## Memorandum

**TO:** Columbia River Crossing Task Force  
**FROM:** CRC Pedestrian and Bicycle Advisory Committee (PBAC)  
**SUBJECT:** PBAC Recommendations for World Class Pedestrian and Bicycle Facilities

### **Purpose of this Memorandum**

### Pedestrian and Bicycle Advisory Committee Recommended Pathway on West Side of West Replacement Bridge (Looking North)

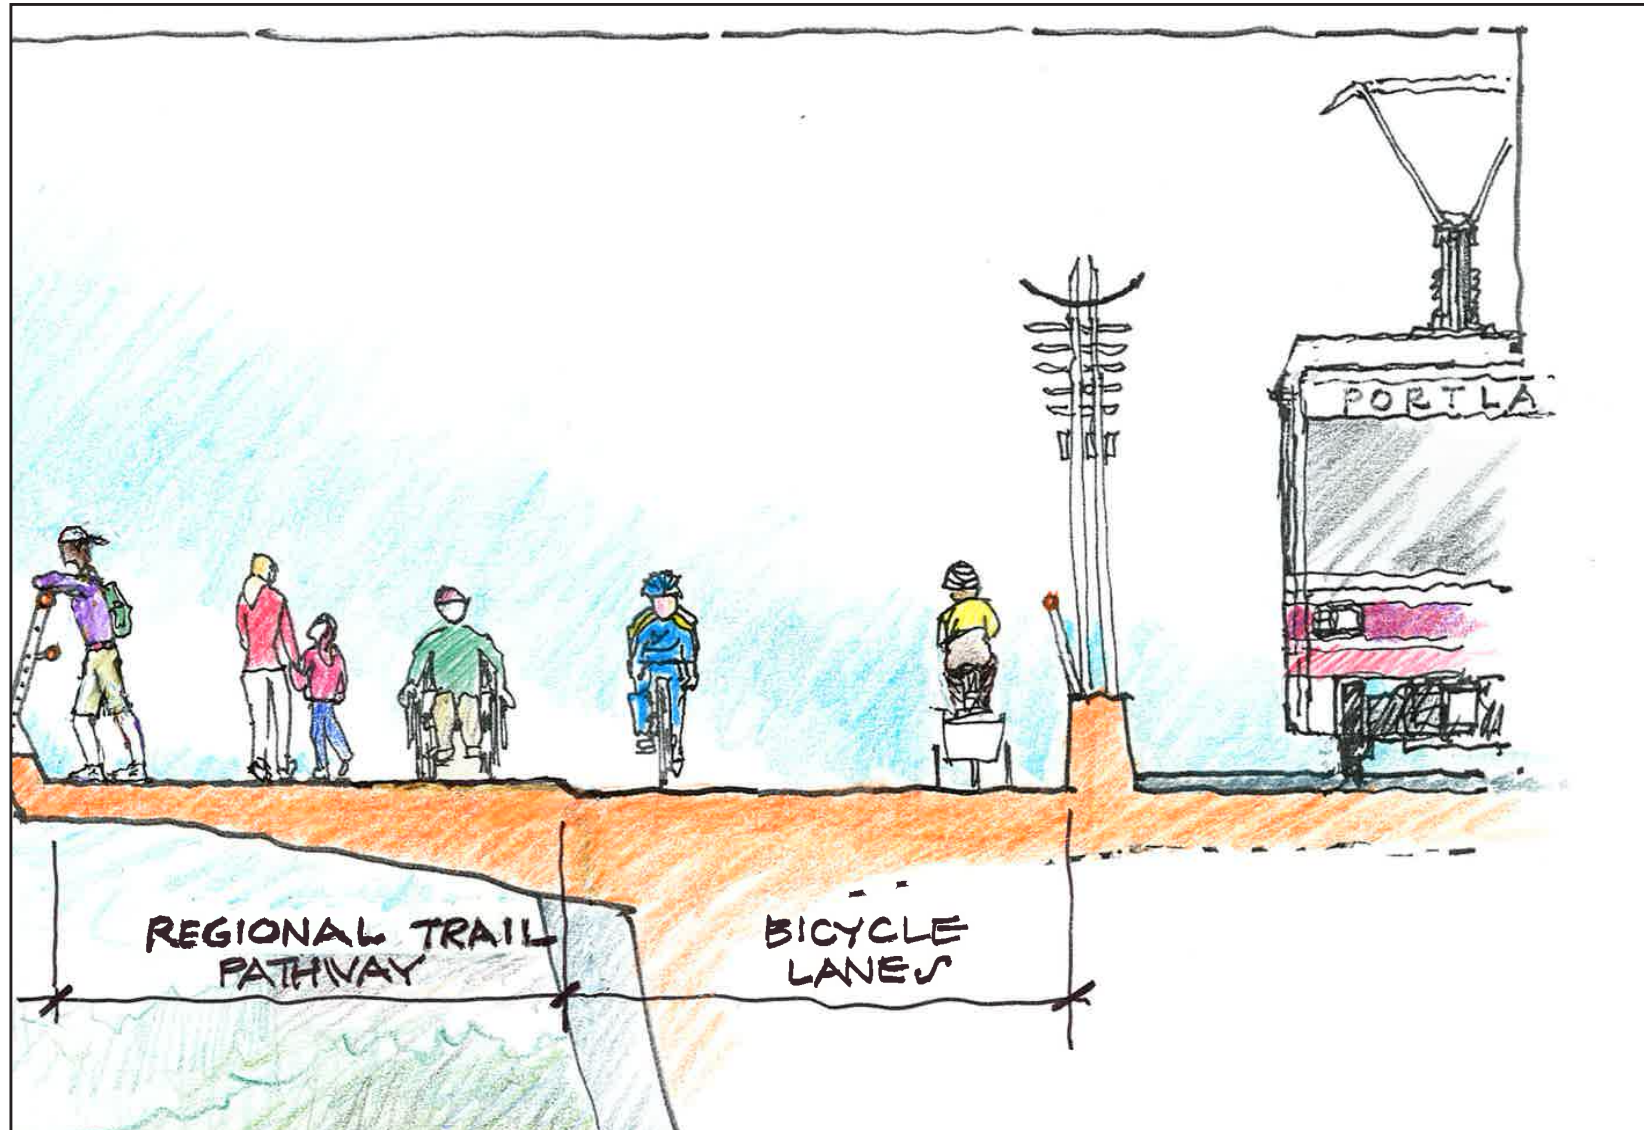
- The overall pathway on the western bridge (adjacent to the transit guideway) must provide separation between recreational users and higher speed bicycle users. To provide this separation, a 12-foot wide regional trail should be provided adjacent to, and to the west of, a pair of six-foot wide bicycle lanes (see attached rendering). These recommended widths are exclusive of potentially needed shy distances, i.e., free and clear of poles and other obstructions to enable safe pedestrian and bicycle movement (a summary of agency standards for multiuse paths, sidewalks and bike lanes is attached).

The regional trail would accommodate pedestrians, persons with disabilities, seniors, families with children, tourists, roller-skaters, and recreational bicycle riders. The adjacent bicycle lanes would be used by bicycle commuters and other faster-moving bicyclists. The regional trail would be at a slightly higher level than the bicycle lanes, but bicyclists in the bicycle lanes would be able to access the trail. Different paving treatments and/or patterns should differentiate the regional trail and the bicycle lanes.
